Before the Board of Inquiry
Waterview Connection Project

Rebuttal evidence of **Gavin Alexander (Ground Settlement)** on behalf of the **NZ Transport Agency**

Dated: 1 February 2011

**ANNEXURE A: UPDATED FIGURE E14 FROM TECHNICAL REPORT
G.13**

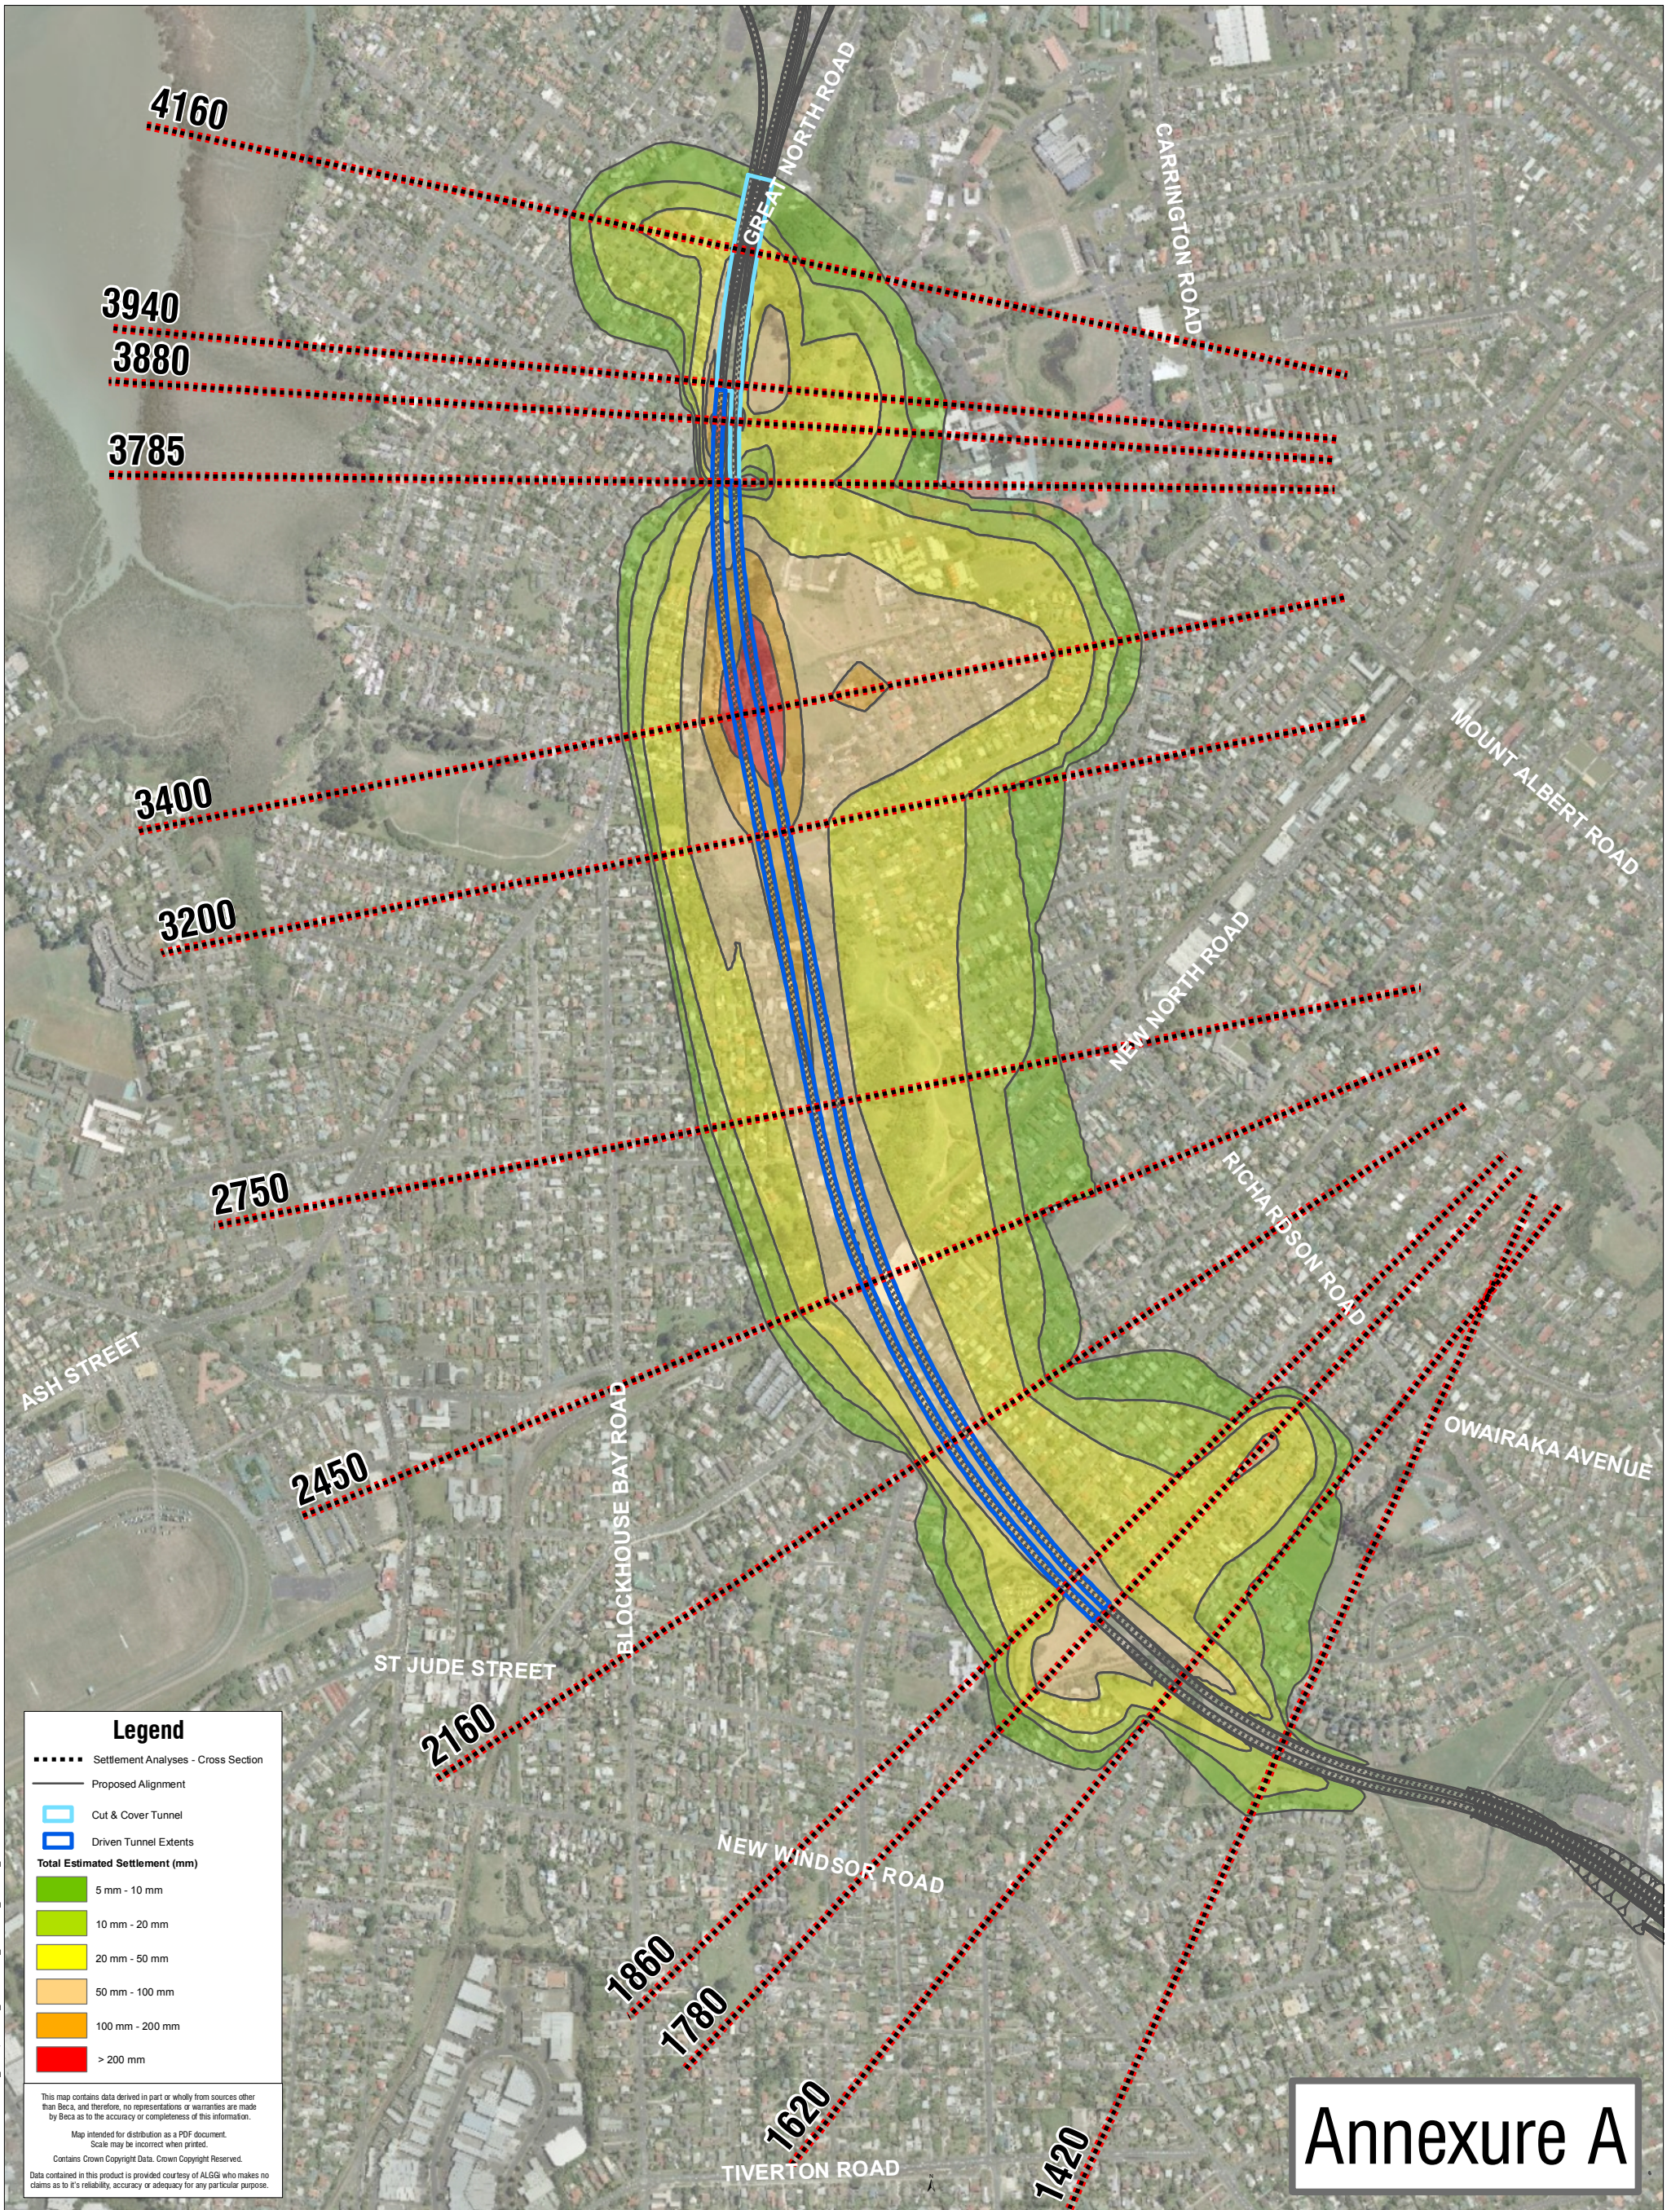
- 35 Earthtech has prepared a Supplementary Section 42A Report on groundwater and settlement effects of the Project. That report formed the basis of much of the expert caucusing on ground settlement. In this section, I comment on the settlement aspects of that report.
- 36 In general, Earthtech appears to agree with the extent of the studies undertaken, the methodologies adopted for estimating settlement and the resulting damage, the conclusions reached in terms of potential settlement related damage, and the available methods for mitigation.⁹
- 37 Earthtech correctly observes¹⁰ that the plan showing total estimated settlement (Figure E14 of Technical Report G.13 reproduced as Annexure A to my EIC) is truncated at each end. I have prepared

an updated version of this plan to correct this, and attach it as **Annexure A** to my rebuttal evidence.

- 49 I see little value in terms of managing and minimising damage resulting from differential settlement from these proposed amendments. Figure E14 of Technical Report G.13 shows considerable areas where the orange coloured 100mm to 200mm settlement zone is less than 30m wide. This implies an average gradient of 100mm or more in 30m, equivalent to 1 in 333 or steeper. The alarm level proposed by Earthtech would be triggered by the predicted settlement, an event that the proposed monitoring regime is already designed to manage.

- 71 With reference to Figure E14, total ground settlement of 5-10mm is estimated at 7 Bollard Avenue. The experts agreed that the potential ground settlement effects on the septic tank at that property will be no more than minor.

- 39 During expert caucusing, I understand the experts agreed to refer specifically to updated Figure E14 and G1 to G4 in Ground Settlement conditions S.1 and S.7, to provide greater certainty.

Each Framework Marker shall have an alert and alarm level set in relation to Figure E14, where alert = 75% of the theoretical value and alarm = 100% of the of the theoretical value with due consideration of the seasonal range of ground movement identified by pre-construction monitoring.
